### **NFPA Technical Committee on Tank Storage and Piping Systems (FLC-TAN)**

#### **MEETING AGENDA NFPA 30 First Draft (A2023)**

## Attachment C

**Figure 26.4.8.2 Cross-Connection of Two Fuel Tanks of Not More Than 660 gal (2500 L) Aggregate Capacity. [31: Figure 8.9.1]**

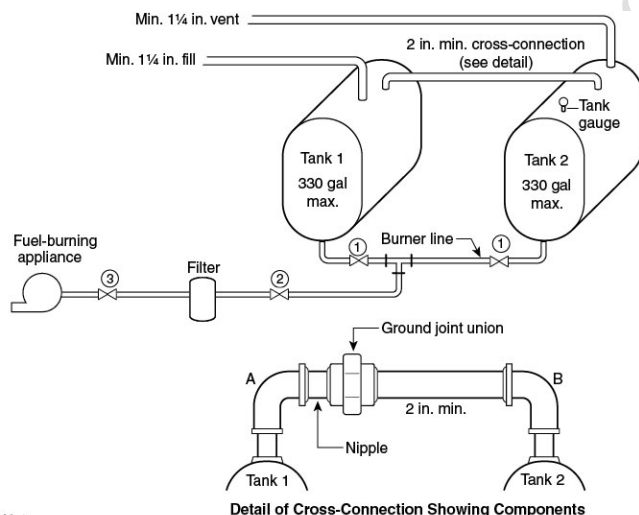
**Commented [MM1]:** Figures to be updated once requirements are agreed upon.

**Figure 26.4.8.3 Cross-Connection of Three Fuel Tanks of Not More Than 990 gal (3750 L) Aggregate Capacity. [31: Figure 8.9.2]**

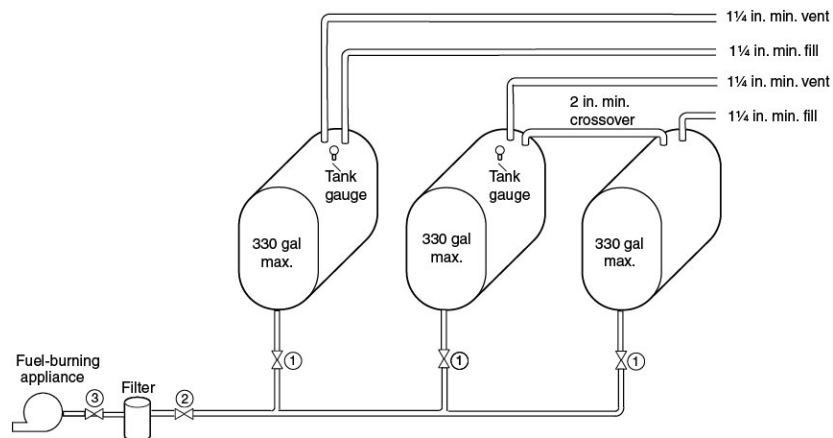
**Commented [MM2]:** Figures to be updated once requirements are agreed upon.
